**SUPPLEMENTAL INFORMATION**  
**ENVIRONMENTAL ACT PROPOSAL**  
**VILLAGE OF GLENBORO**  
**WASTEWATER TREATMENT LAGOON UPGRADE**  
**MUNICIPALITY OF GLENBORO-SOUTH CYPRESS**

PROJECT NO.: SEI2021-024

JUNE 21, 2021

## **Additional Information Request**

DRAWING TITLE: GLOBAL SITE PLAN & GENERAL LAYOUT PLAN

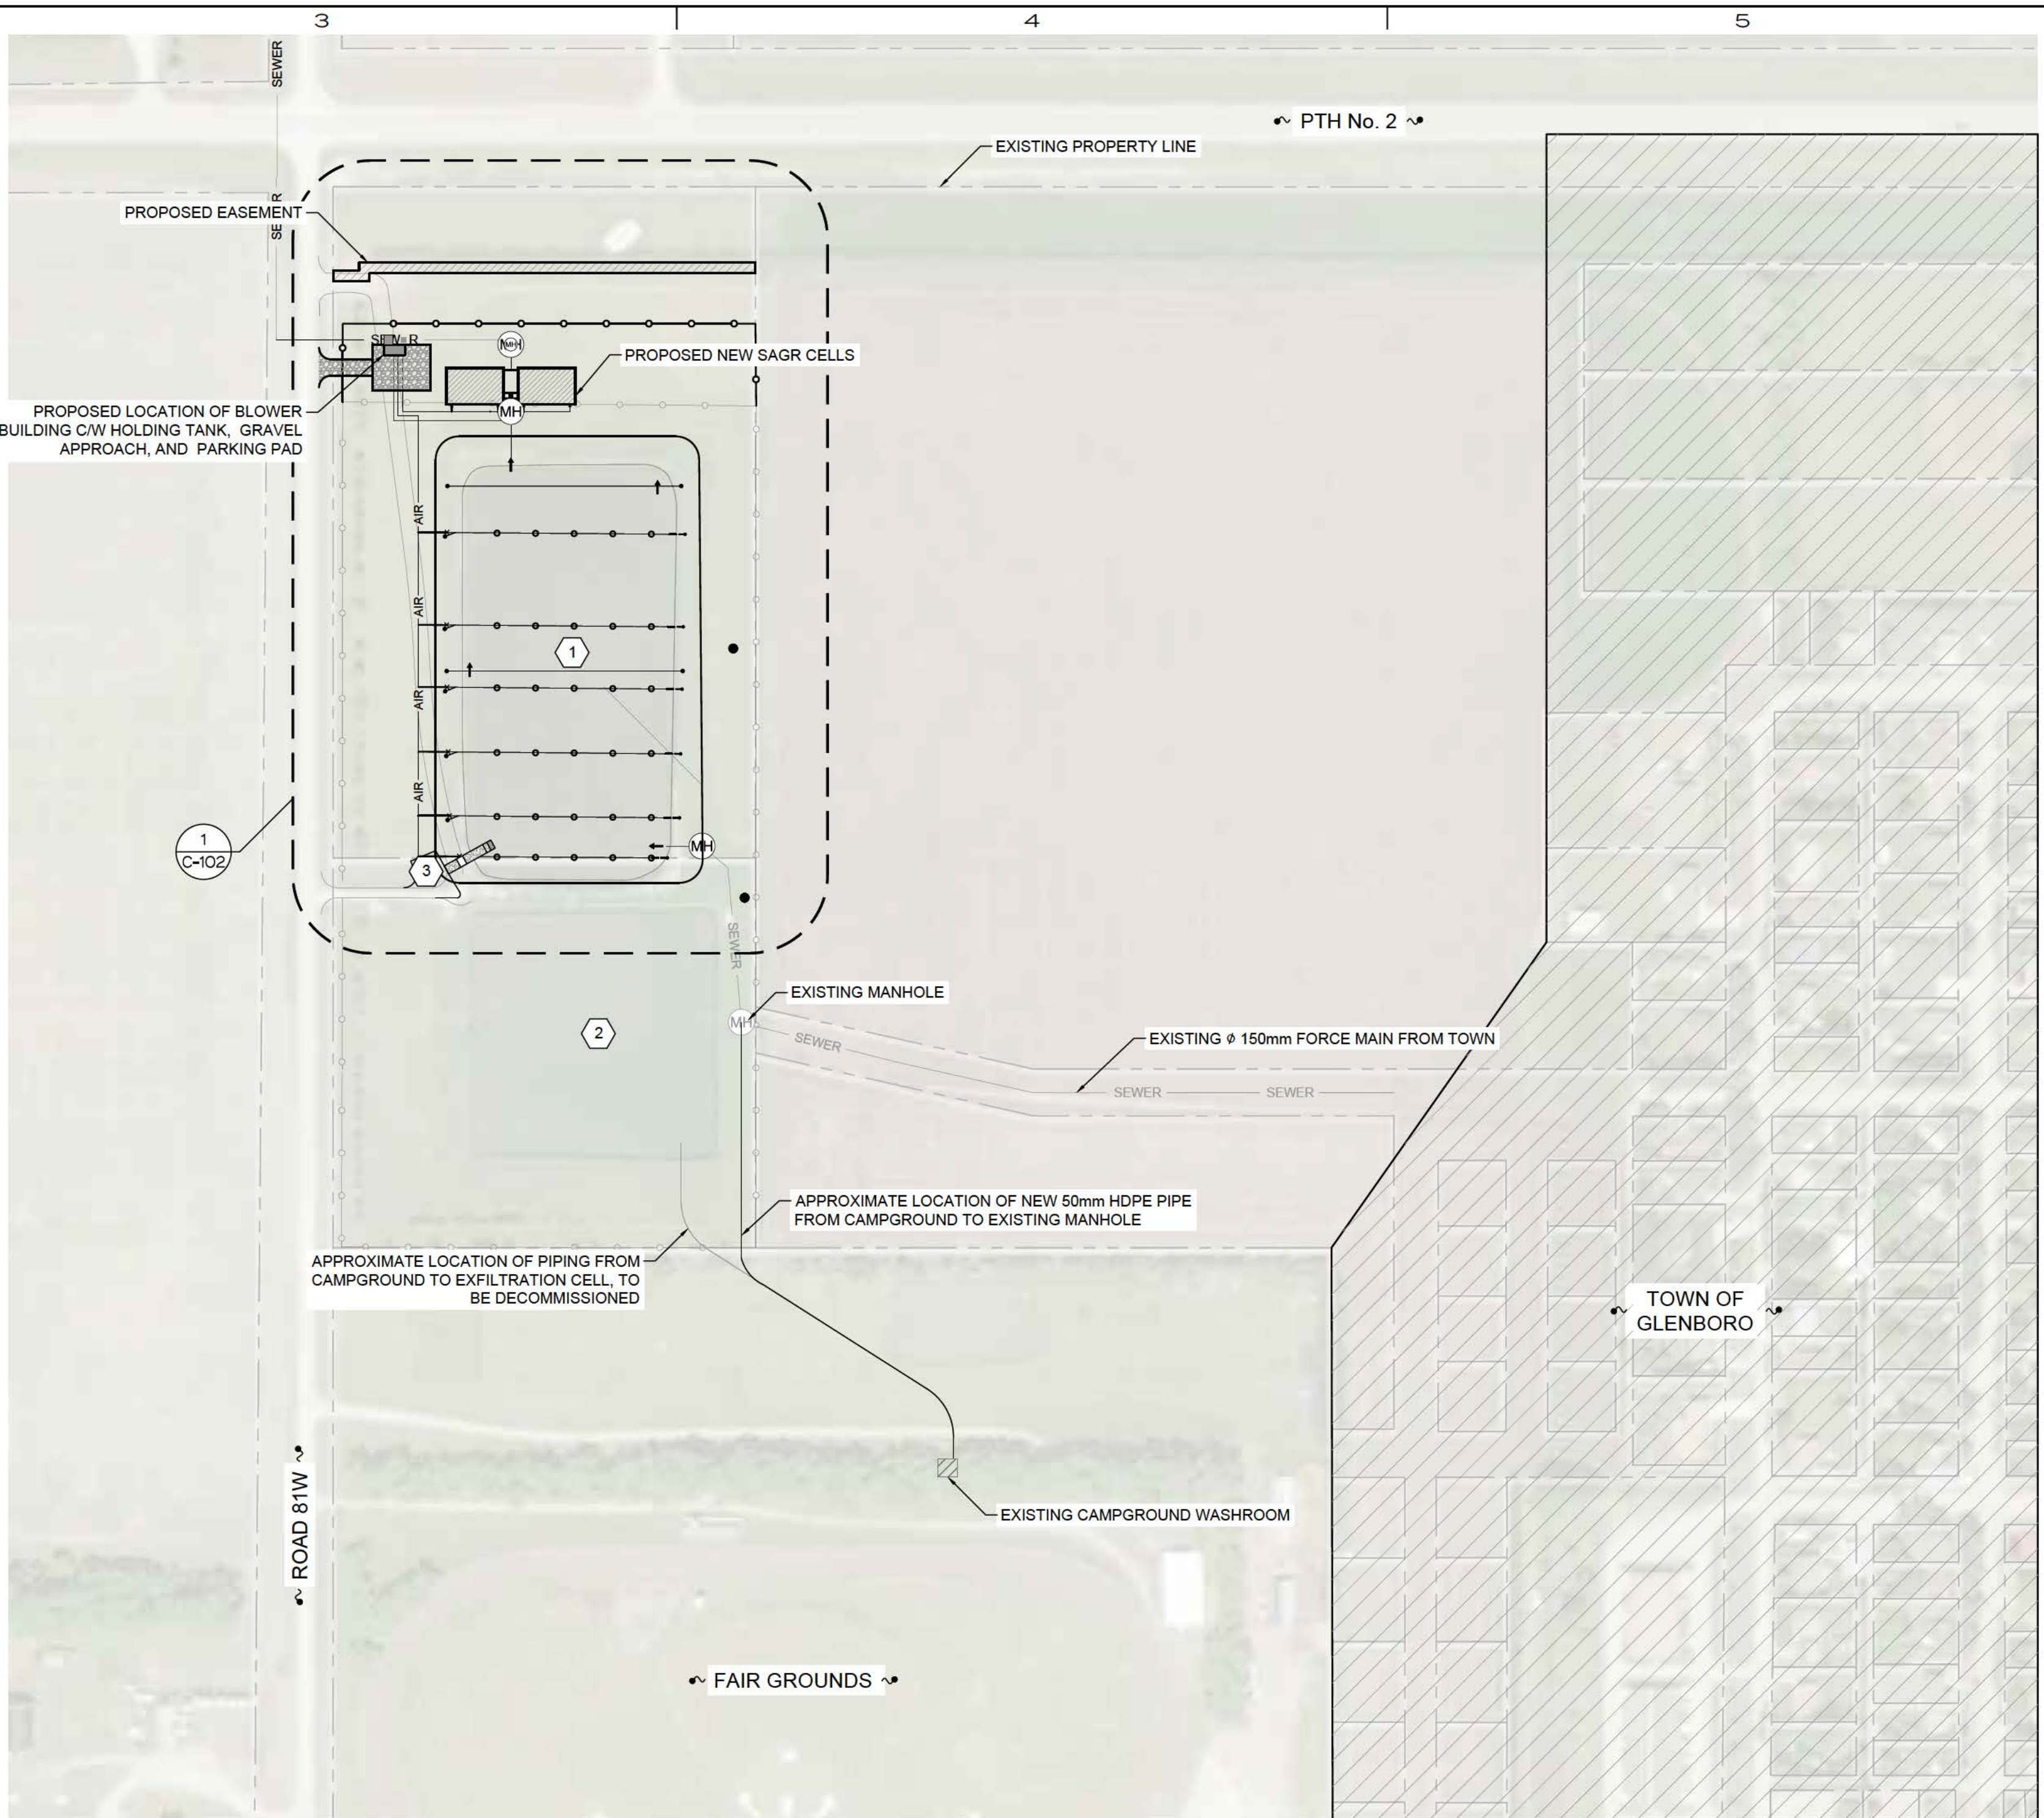
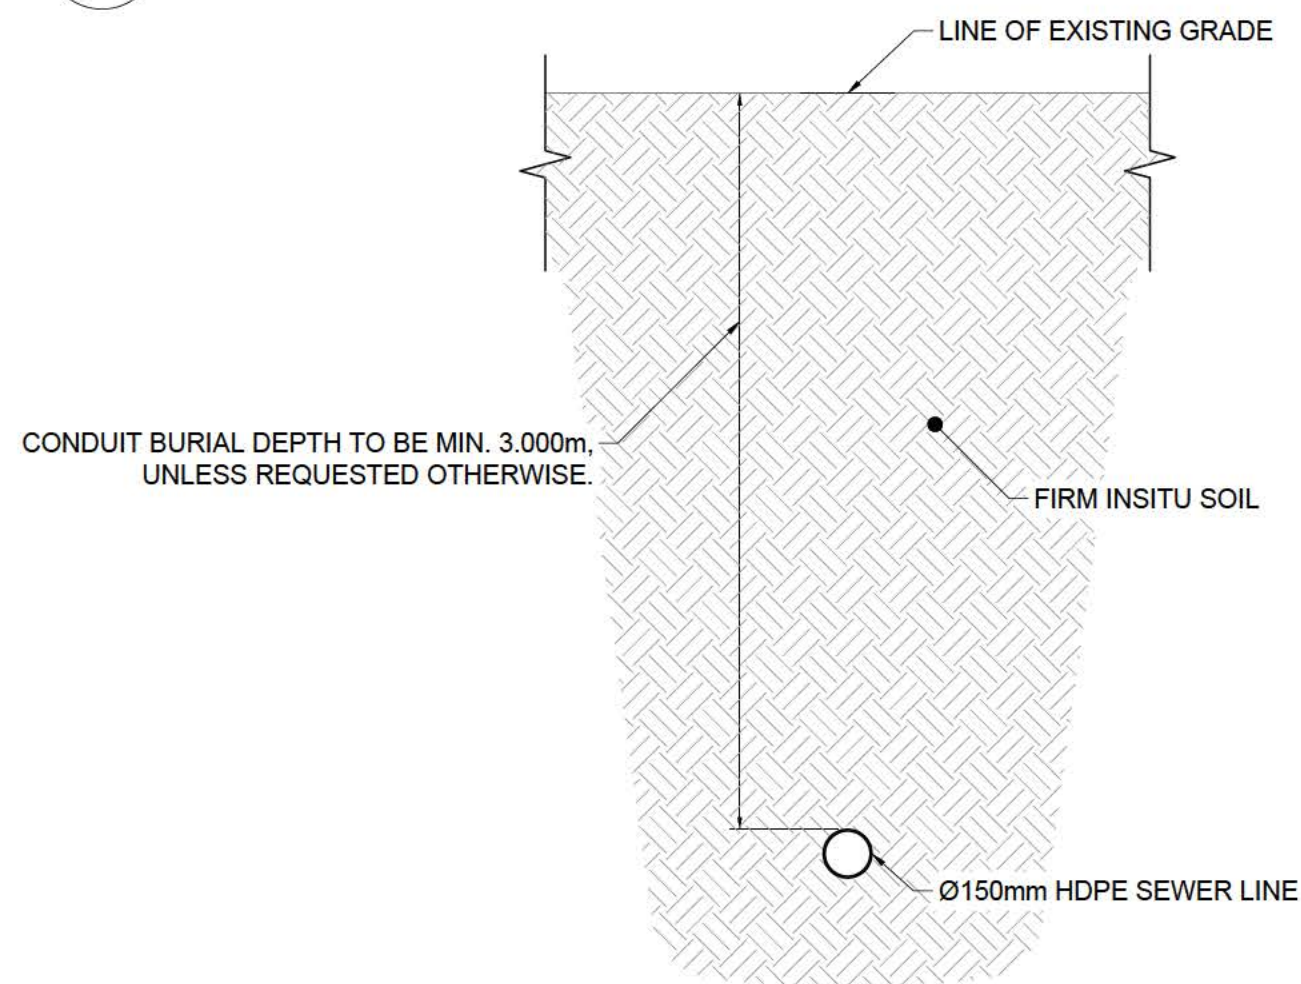
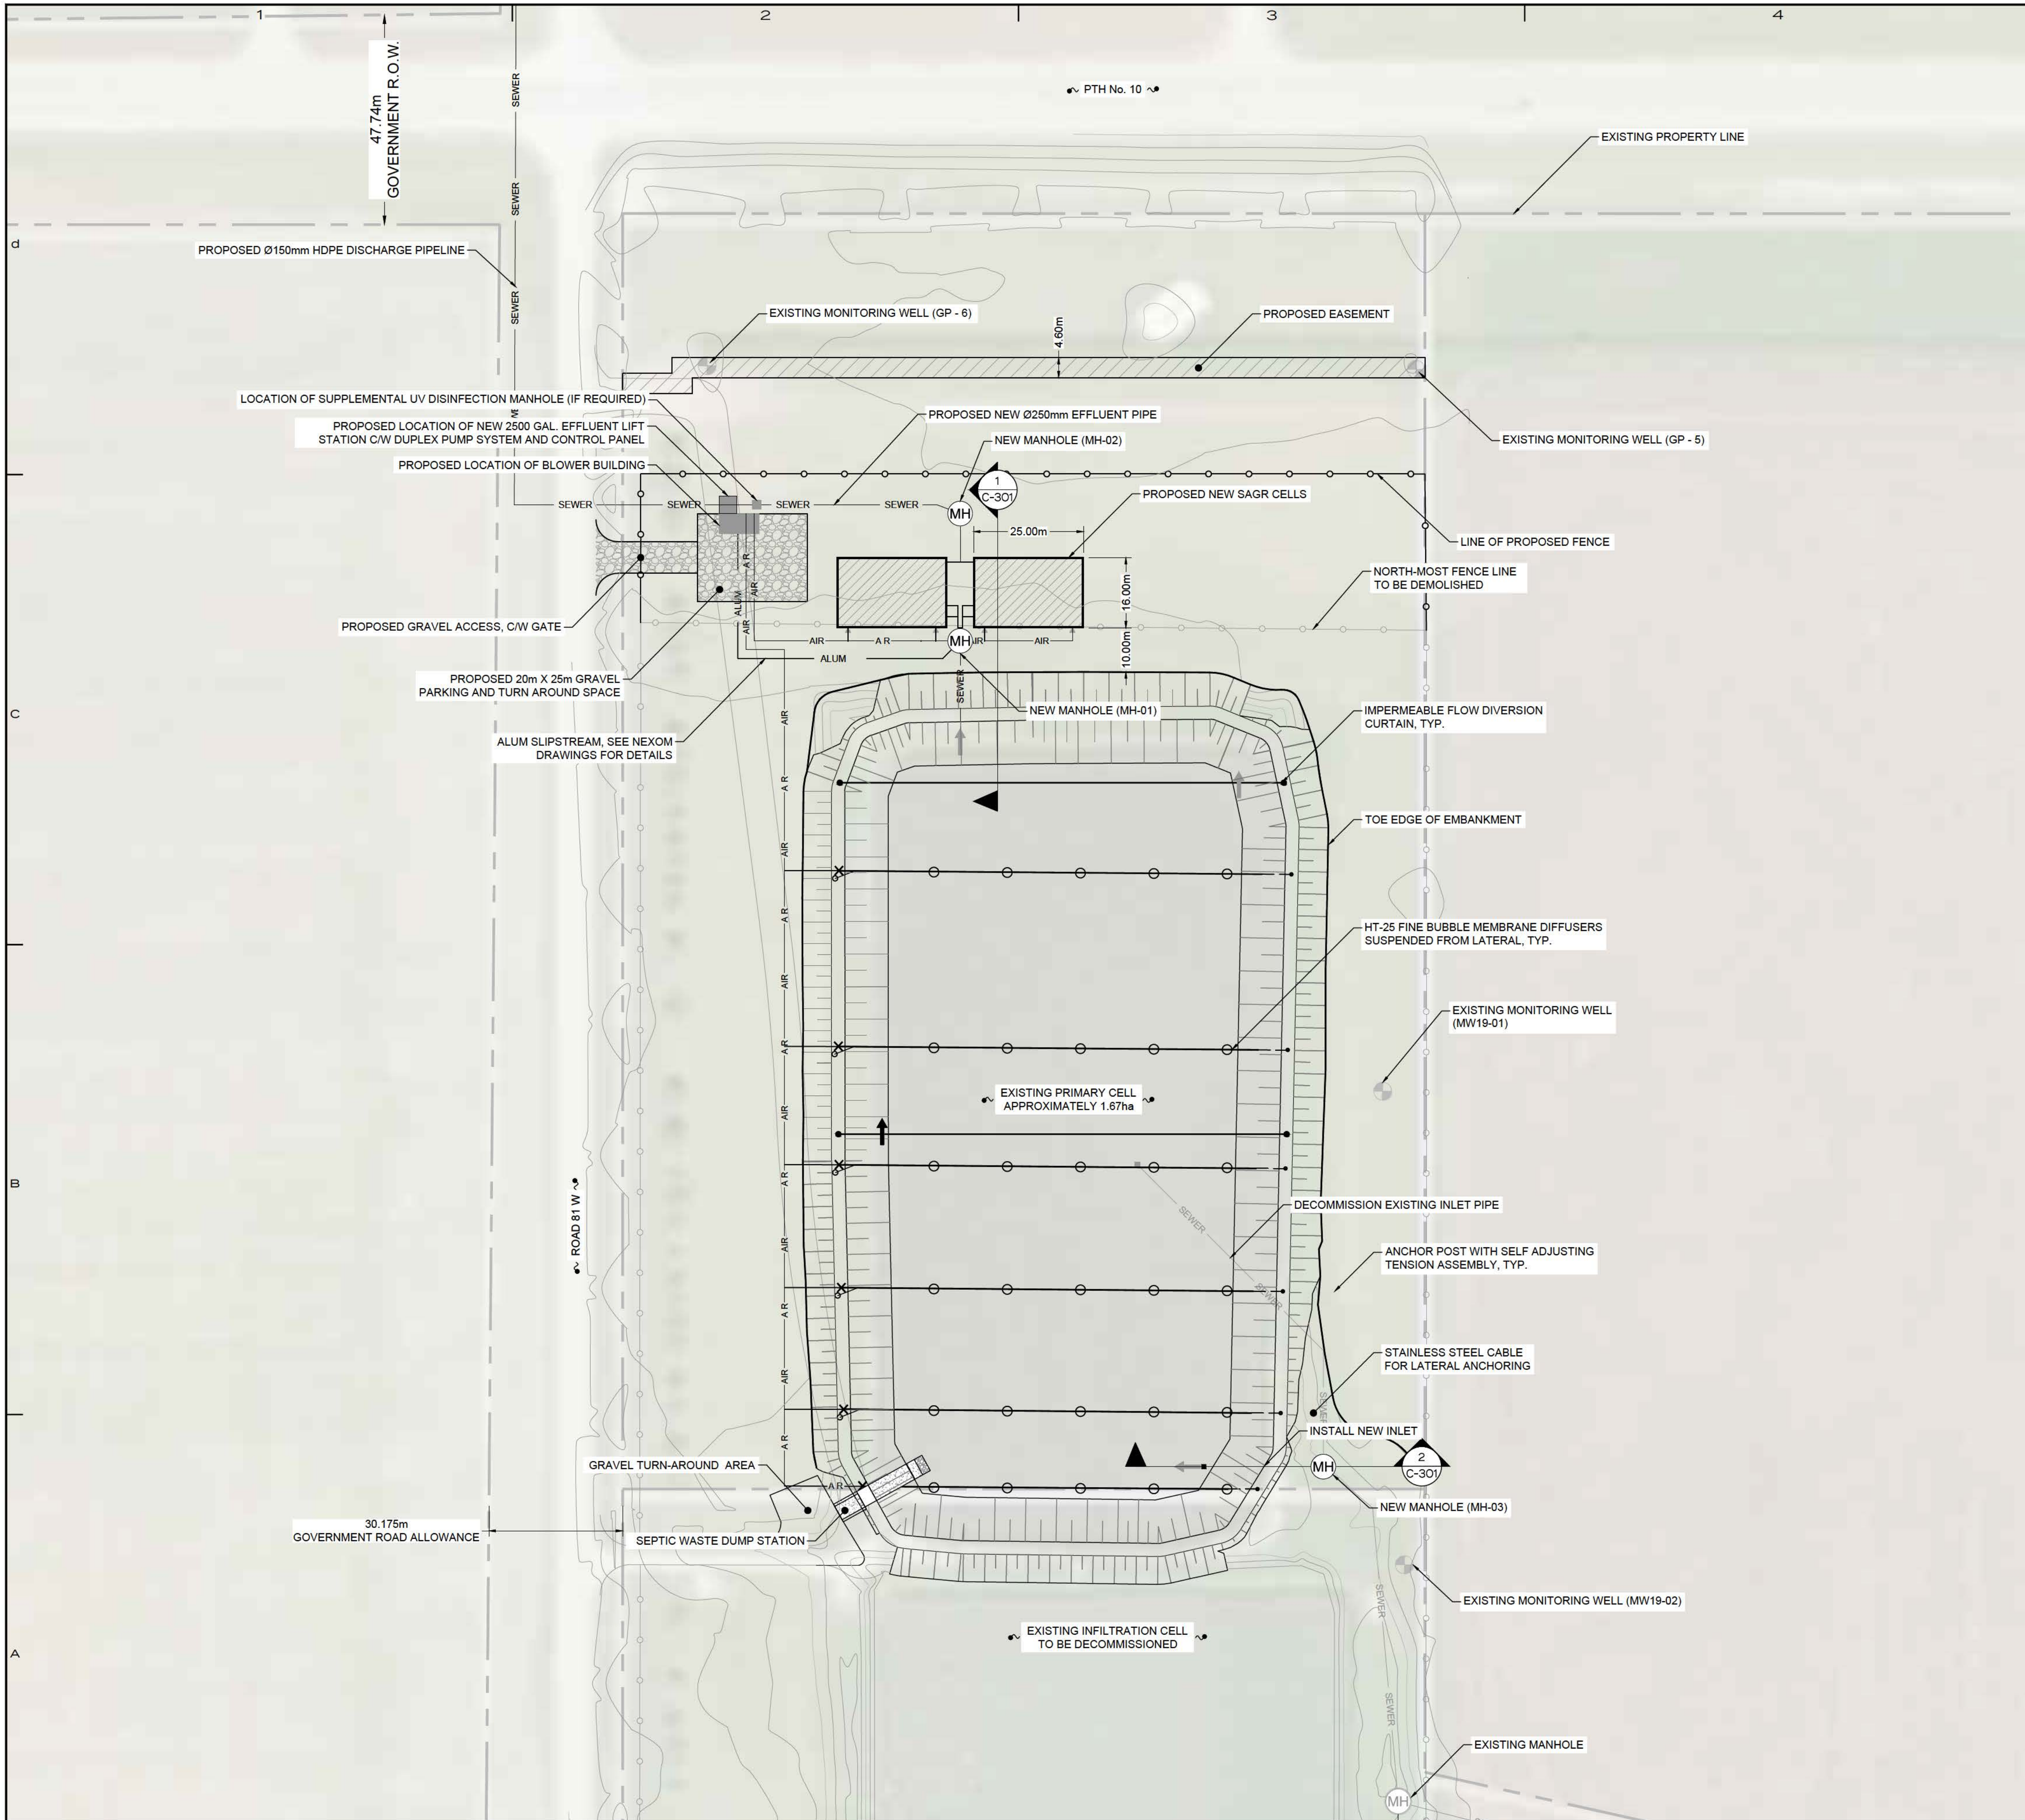
*“What side of Road 81W will the force main follow? Appendix A appears to show it to follow the east side of the road allowance, while the text suggest that it is adjacent to SE-21-0007-14W1 (west of road). Please comment.”*

*“Please comment on the pipeline installation method that will be used to install the effluent forcemain. It should be noted that the proposed project is routed across patches of hairy-prairie clover listed as Threatened under the Endangered Species and Ecosystems Act. This species occurs within the road right of way, and impacts are not mitigated by limiting activity to within the previously disturbed ditch area. There is also a risk to disturbing or destroying prairie skink, listed as Endangered under The Endangered species and Ecosystems Act and the federal Species At Risk Act, as this species has been observed immediately east of the right of way. Potential conflicts occur along Road 81W, within an approximate 100 metre stretch between SE-21-007-14W1 and SW-22-007-14W1, directly east of the golf course. It is recommended to use directional drilling within approximately 100 metre stretch of right of way to prevent negative impacts to species*

*protected under The Endangered Species and Ecosystems Act and Species at Risk Act. The installation of the pipelines by plow method may impact the above species.”*

The proposed Site Plan has been provided as Drawing C-102 in Appendix B. The Global Site Plan and General Layout Plan identify force main and discharge locations in Details 1 and 2, Drawing C-101.

The force main will follow the west side of Road 81W. Please see Drawing C-101 in Appendix B for additional detail.

The proposed Ø150mm force main is to be installed along the west side of road 81W approximately 3m from the property line and will be installed via Horizontal Directional Drill and plow method. The locations and lengths of the directional drilling are shown in Detail 1 of Drawing C-101 in Appendix B. The depth (minimum 3m from surface) and directional drill detail is shown in Detail 3 of Drawing C-101 in Appendix B. The force main will be installed via directional drilling for the areas of special concern, including the area directly east of the golf course, which will minimize impacts to the prairie skink and Hairy Prairie-Clover. Prior to construction, a review of the west side of Road 81W will be conducted to determine areas populated by Hairy Prairie-Clover and prairie skink and if found outside of the area already identified, the use of directional drilling will be expanded.

The location of the force main, the areas that will be directionally drilled, and the location of the outflow and pad are shown on Drawing C-101 in Appendix B. The outflow and pad will be located at Latitude: 49°36'22.00"N, Longitude: 99°19'1.00"W.
